Westinghouse  
Electric Company

Subject: AP1000 Pre-Application Review – Acceptance Review of Codes Submission  
and Responses to Requests for Additional Information pertaining to the AP1000  
Pre-Certification Review

## AP1000 PRE-CERTIFICATION REVIEW

### REQUEST FOR ADDITIONAL INFORMATION

Figure 004-1

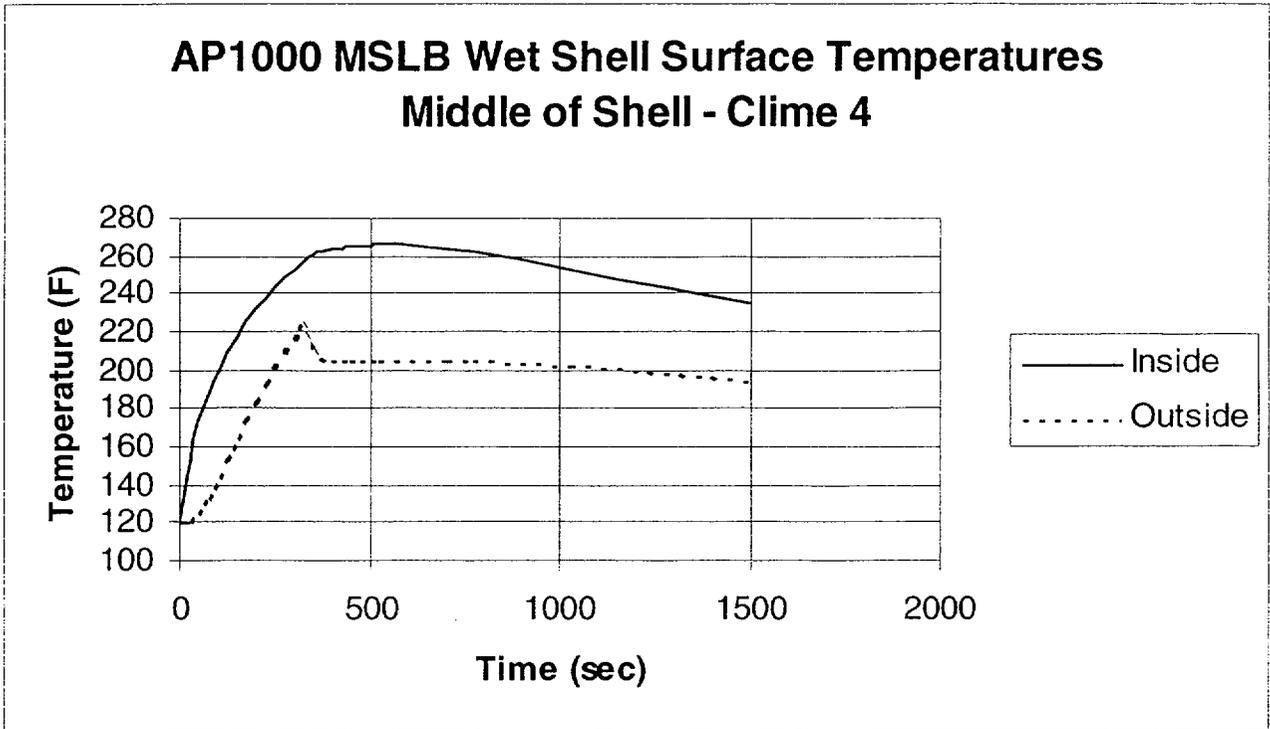
- P4 (b) The shell temperatures for the steam line break rather quickly exceed the boiling temperature on the outside of the shell. The results of a sensitivity study with no PCS water were shown. Does this mean that Westinghouse will take no credit for PCS water in the steam line break licensing analysis, and only credit heat transfer through the dry shell? Given the high temperature how will Westinghouse justify compliance with GDC 38?

Figure 3.4-9 of WCAP-15612 presents the AP1000 scoping analysis results for the shell inside surface temperature transient of a representative clime during an MSLB event. Figure P004-1 presents a comparison of the Clime 4 inside and outside shell surface temperature transients from the scoping analysis model. The application of PCS water causes the outer surface temperature to rapidly decrease and subsequently remain below the boiling point. As shown in Figure P004-2, the AP1000 wet shell temperature response for the MSLB event is similar to the AP600.
